## INSPECTORS REPORT

WASTE LICENCE REGISTER NUMBER 164-1

APPLICANT: Dunloe Ewart PLC

FACILITY: **Former Hammond Lane Metal Company\Molloy & Sherry Site.**  
**Site Contained by the following street frontages: Sir John Rogerson's Quay to the North; Britain Quay to the East; Green Street East to the South; and Benson Street to the west.**

**Figure 4:**  
**Schematic diagram of PRB Cell within the bentonite slurry cut-off wall.**

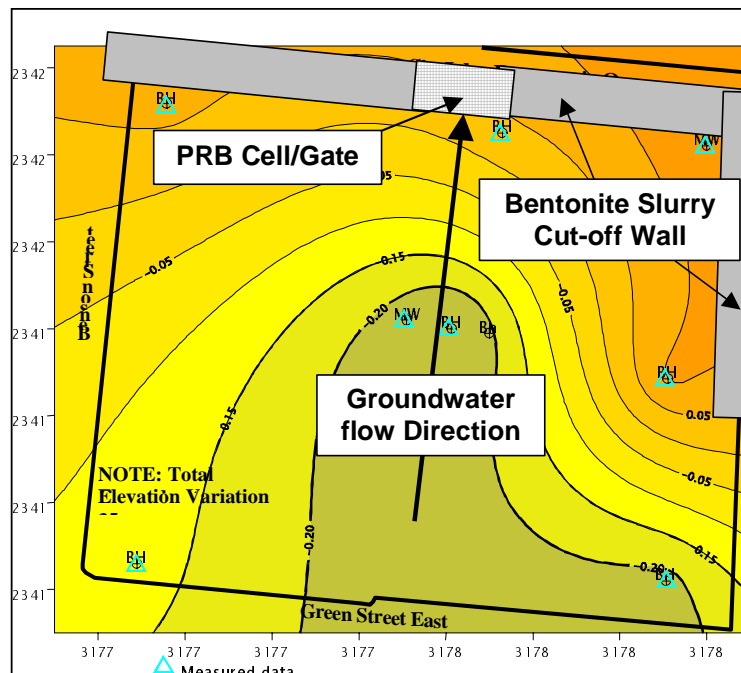
Groundwater flow is considered to be relatively stagnant but in general the flow direction is northeastwards towards the River Liffey. The groundwater treatment design consists of a three sided bentonite slurry cut-off wall on the north and east sides with a PRB cell/gate installed midway along Sir John Rogerson’s Quay to capture and treat the groundwater. The bentonite slurry cut-off wall will be approximately 300m long and will be keyed 0.7m into the natural clay till soils. Figure 4, next page, is a schematic diagram of the system in plan.

The design of the slurry wall controls the groundwater head inside the site to ca. -0.35m OD. There will be a sump pump at the base of the PRB cell to augment the slow flows of groundwater and drive the groundwater through the PRB cell and on into the River Liffey. The daily flow of contaminated groundwater through the PRB cell is envisaged to be no more than 2m<sup>3</sup> per day, but the PRB cell pump will be designed for a maximum volume of 11m<sup>3</sup> per day (4,015m<sup>3</sup>). **Full design details are still to be completed.**

These shall be forwarded to the Agency for agreement as per the Specified

**Engineering Works, Schedule B of the proposed decision (Condition 3.11.2).**
